# UNITED STATES PATENT AND TRADEMARK OFFICE

APPLICATION NO.	FILING DATE	FIRST NAMED INVENTOR	ATTORNEY DOCKET NO.	CONFIRMATION NO.
10/764,071	01/23/2004	Toros Kejejian		8003
7590 08/10/2005 Stephen E. Feldman, P.C. 12 East 41st Street New York, NY 10017			EXAMINER REESE, DAVID C	
			ART UNIT 3677	PAPER NUMBER
DATE MAILED: 08/10/2005

**Office Action Summary**

### **DETAILED ACTION**

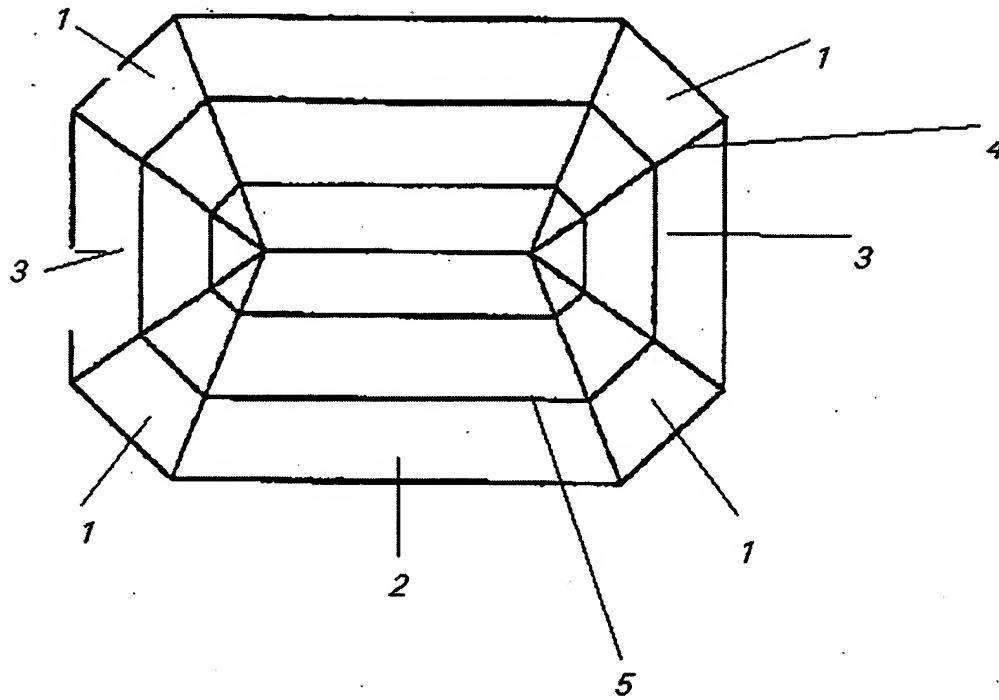
As for Claim 1, Namdar teaches of a mixed cut gemstone (see next page) comprising:  
a pavilion (Fig. 5);  
four lower corner facets (1), said lower corner facets being triangles (1);

two long-side lower girdle facets (2), said long-side lower girdle facets being triangles or trapezoids (2);

two short-side lower girdle facets (3), said short-side lower girdle facets being triangles (3);

a plurality of step cuts (5), said step cuts being substantially equal in width; and

a plurality of rib lines (4);

said steps being at a predetermined angle with respect to said lower girdle facets with each step being at a slightly different angle.

REPLACEMENT DRAWINGS

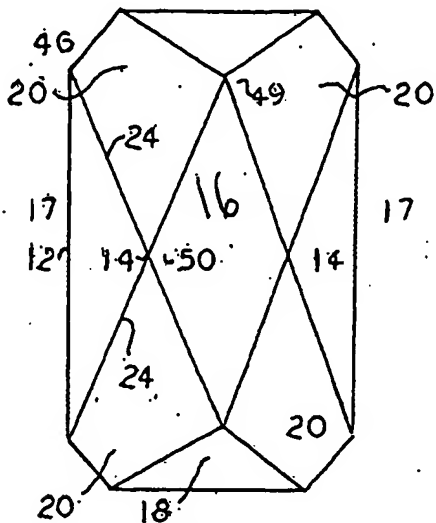
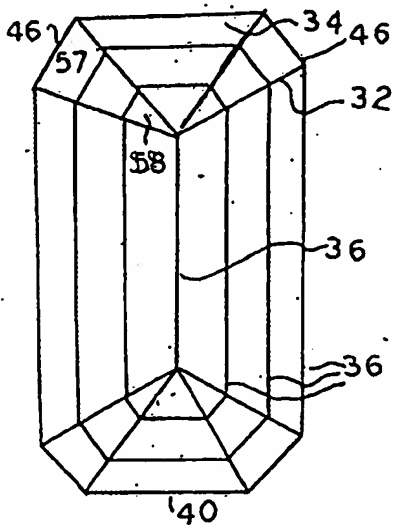
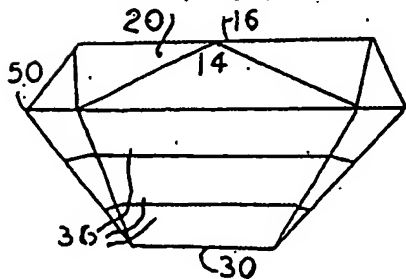
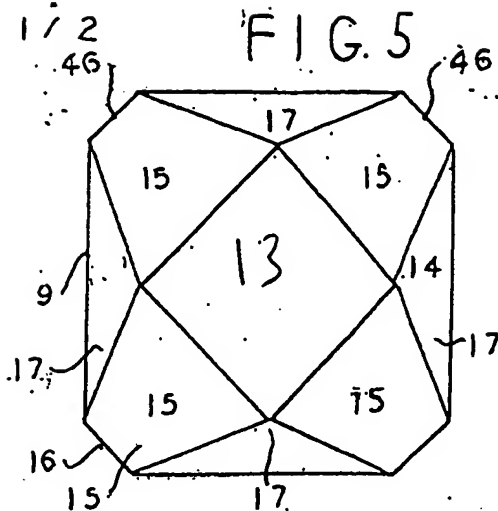
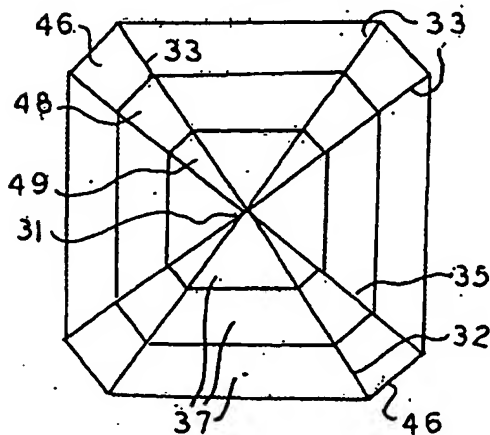
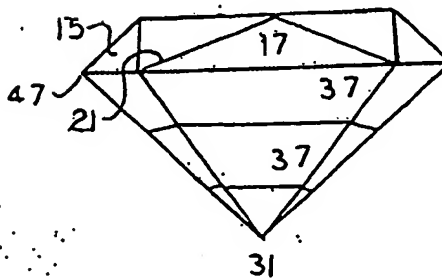
- [2] The drawing(s) were previously objected for informalities. In view of Applicant's replacement drawing submitted on 7/20/2005, all previous objection(s) to the drawings have been withdrawn. Accordingly, the replacement has been entered.
